Access Compliance Report

Public Rights-of-Way

| Intersection ID: 4413 | Main Street: CHASTAIN_PARC_DR | Cross Street: WATTS DALE_AV | Location: SE |
| ADA ID: A9B73326E20A | Ramp Type: BlendTrans1 | Initial Pass/Fail: Fail | Overall Compliance: No |

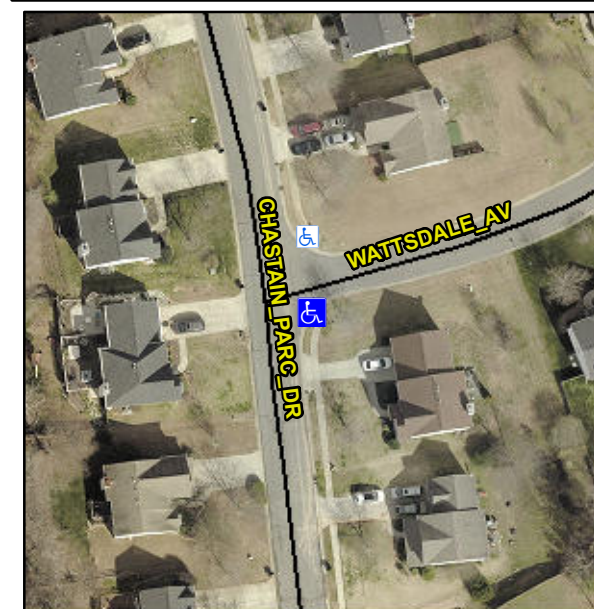
Not Found, R304.5.1, R304.5.3

| Compliance | Description | Data | Compliance | Description | Data |
|------------|-----------------------|------|------------|-----------------------------|------|
| No | Ramp Width (in) | 46.0 | No | BlendTrans XSlope (%) | 8.6 |
| | | | No | Curb Slope (%) | 21.6 |

Remove & Replace Curb Ramp With Two New Directional Ramps or Equivalent.
